UNIVERSITY OF MISSOURI

Research Reactor Facility

REFERENCE: Docket 50-186
University of Missouri

SUBJECT: Change to University of Missouri Research
Reactor Facility License No. R-103

Figure 1
MURR Fuel Element

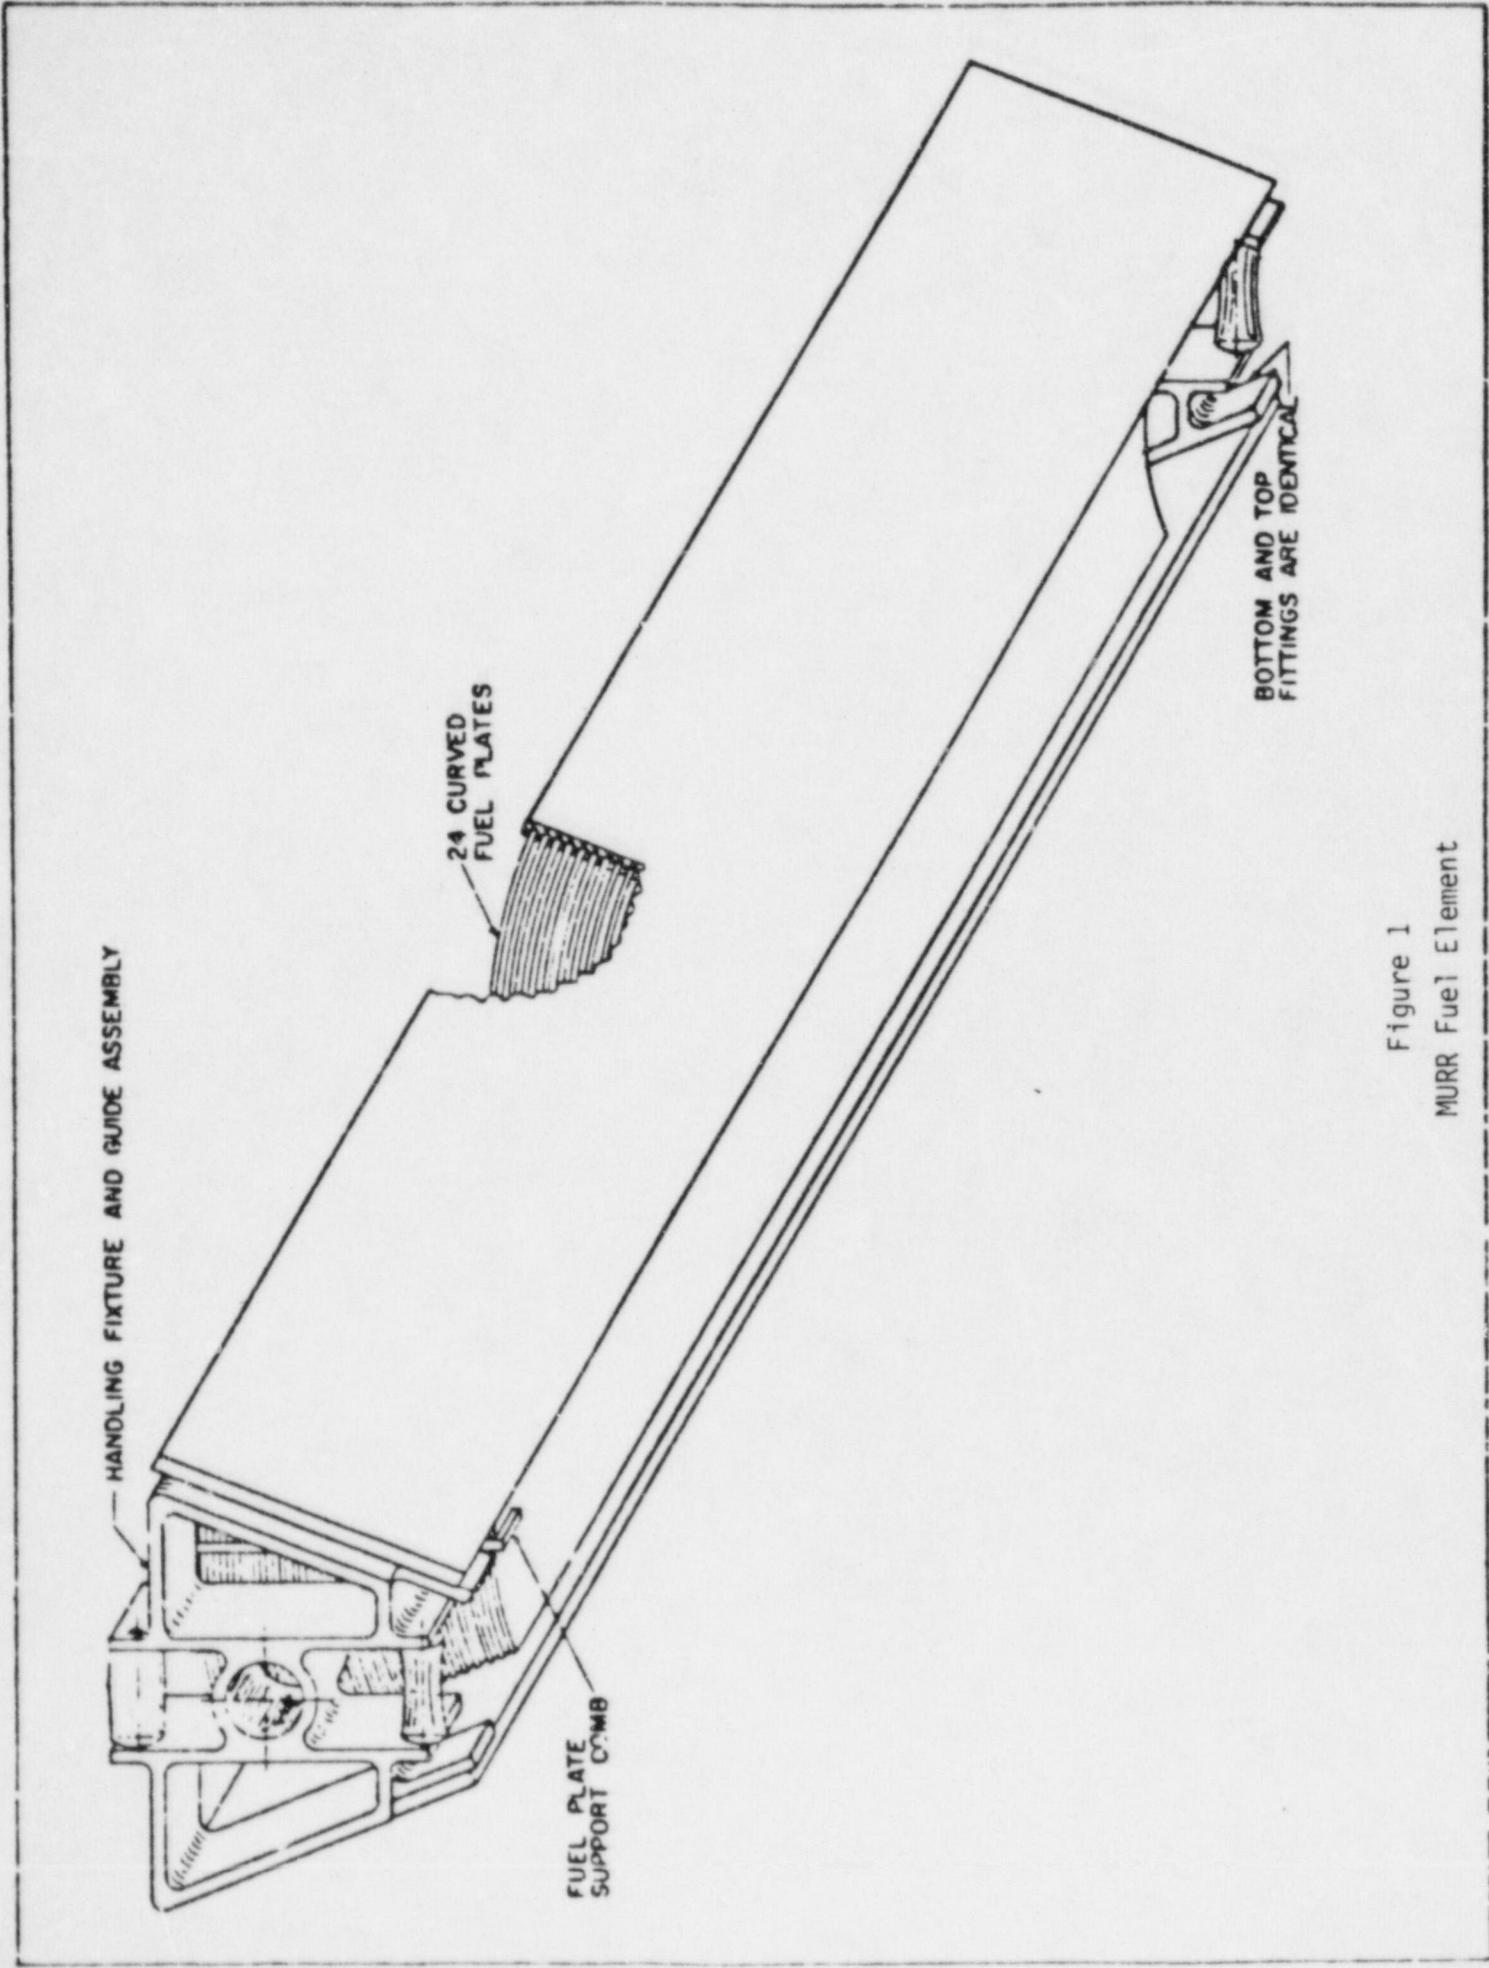
The new fuel element will have the same appearance and dimensions as our current fuel element (figure 1). The only changes are the uranium loaded per fuel plate and boron carbide included as a burnable poison in selected plates. The amount of uranium (U-235) and boron loaded per plate are given for the present and new fuel elements in table 1. Our present element (775) has all the fuel plates loaded to a uniform 1.55 grams uranium (93% enriched in U-235) per cubic centimeter (cm^3) of fuel meat. The increase in grams per plate for the 775 element is due to the size of the plates increasing from plate 1 to plate 24. The density of uranium in the new element (1270) fuel meat decreases from plate 8 to plate 1 and from plate 19 to plate 24. Fuel plates 8 through 19 are loaded uniformly at 3.0 grams uranium (93% enriched in U-235) per cm^3 . Both fuel elements are made from aluminide UAl_x fuel clad with aluminum. The 775 element is made from UAl_x that is mostly in the UAl_3 phase while the 1270 element UAl_x is mostly in the UAl_2 phase. Table 2 compares the significant differences between the two elements. Enclosure A is the specification for fabrication of the University of Missouri 775 gram U-235 fuel element. Three changes are required to this specification for fabrication to cover the new fuel element. In paragraph 3.4.2(1) on page 14, the 775 gram loading will be changed to 1270 grams. The U-235 and boron loadings given in table 1 of this submittal will replace the values given in the table on page 24. UAl_2 will replace UAl_3 in paragraph 3.3.2 on page III-4.
